G3NO-2008-00021

SUBJECT: Responses to NRC Requests for Additional Information, Letter No. 17
(GG3 COLA)

RESPONSE TO NRC RAI LETTER NO. 17

RAI QUESTION NO. 03.07.01-1

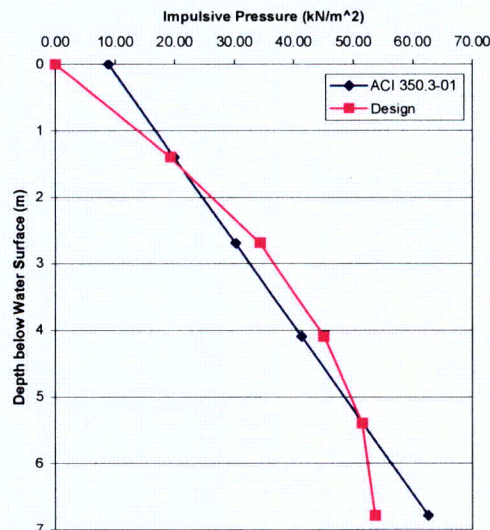
2. With reference to item (b) above, discuss the methodology used in computing the sloshing frequencies and sloshing response of the pools in Reactor Building/Fuel Building (RB/FB), and list the analysis results for the pools in the RB/FB. Based on the analysis results, demonstrate that the sloshing response is only a small portion of overall seismic-induced hydrodynamic loads on the pool structure and does not govern. Explain the rationale for the GGNS statement that majority of hydrodynamic loads are due to the impulsive response of the water and compare the method used in determining the impulsive response to those used in ACI 350.3 or equivalent codes and standards. Lastly, use the RB/FB analysis results to justify the GGNS statement that the impulsive response inherent in the CSDRS-based design is typically an order of magnitude higher than the sloshing response at lower accelerations, of the FIRS.

The impulsive pressures using the ACI equations compared to the design impulsive pressures are shown below for GDCS Pool A, which is not fully rectangular but was analyzed as an equivalent rectangular tank.

The two pressure distributions are reasonably close with the design pressures being higher in the middle portions of the wall and the ACI pressures being higher near the wall edges. The higher design pressures in the wall's middle span are more critical to the out-of-plane bending of the wall. The total lateral impulsive forces computed to be the area under the curve are

1251 kN and 1266 kN using the design method and ACI method, respectively. The difference is only about 1%, which is negligible.
